PROPOSED ~~INFILTRATOR~~ CONTACTOR* LEACHING SYSTEM

(REPLACEMENT SYSTEM)

LOCATION: CHASE ROAD
SOUTH HAMPTON, N.H.

APPROVAL: #170396 *AMENDED 12/17/92
(SEE DETAIL FOR REVISED SYSTEM LAYOUT)

PLAN SCALE: 1" = 20'

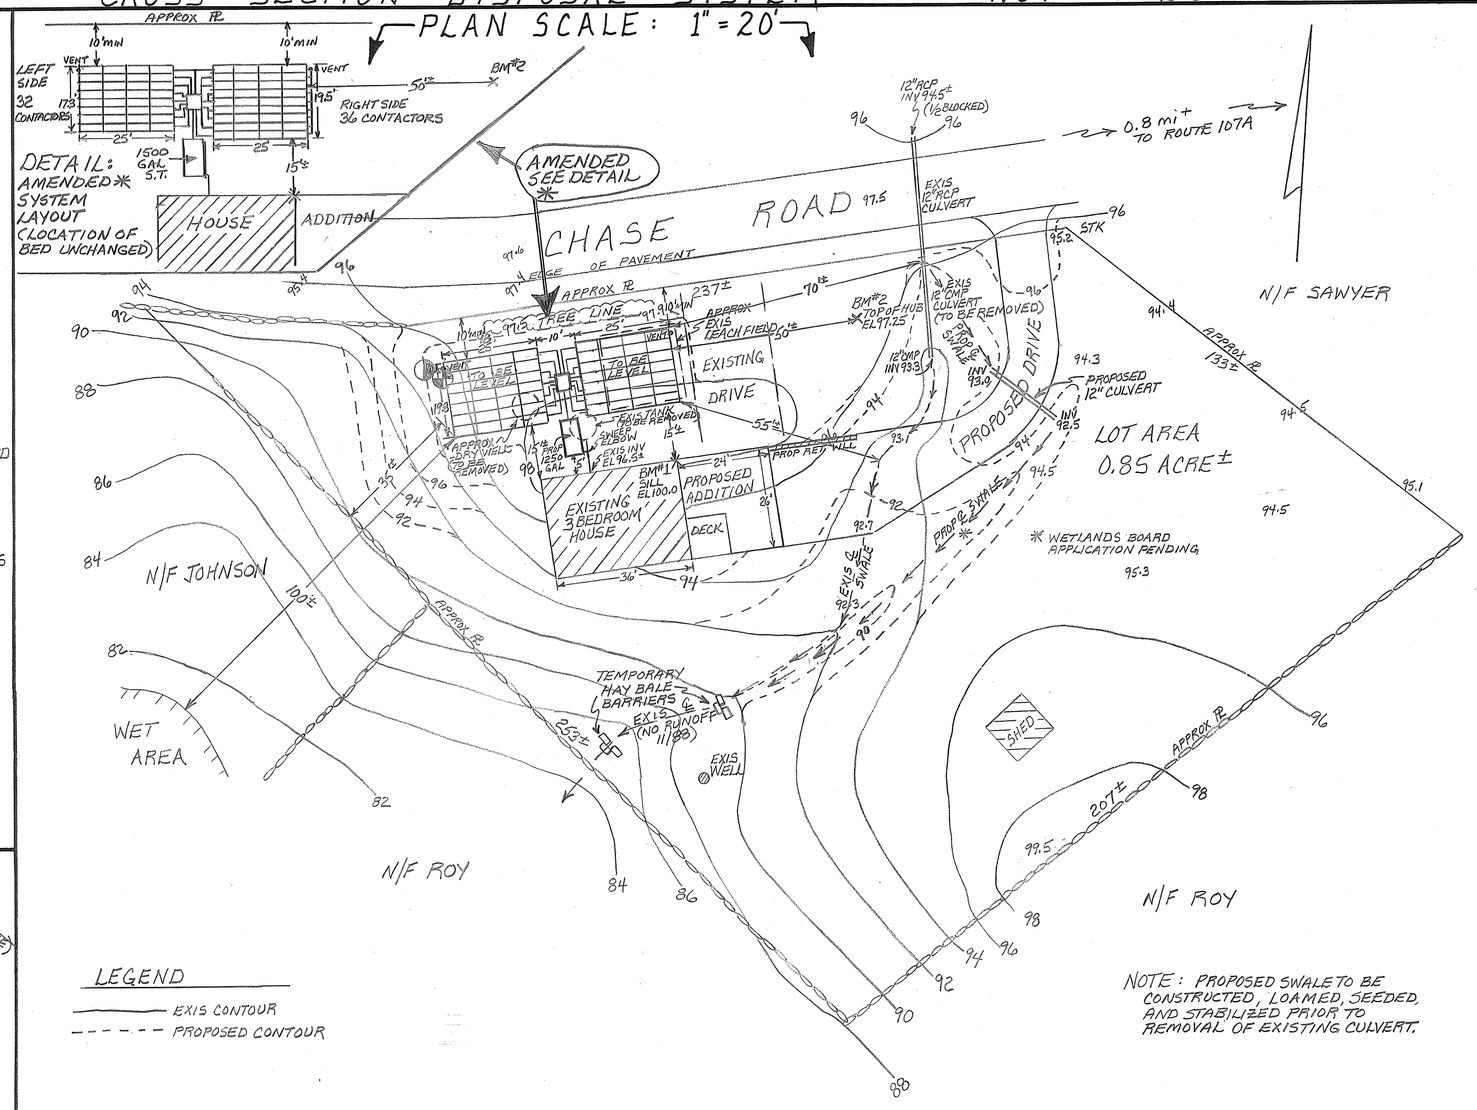
(* PLAN AMENDED TO SHOW USE OF 12" CONTACTOR CHAMBERS INSTEAD OF 15" INFILTRATORS (SEE DETAIL BELOW FOR AMENDED BED CONFIGURATION) NO FIELD WORK 12/92 - INFO PROVIDED BY INSTALLER

AREA PROVIDED: 68 CONTACTORS @ 15SF EACH * EQUALS 1020SF PROVIDED

* AMENDED 12/92
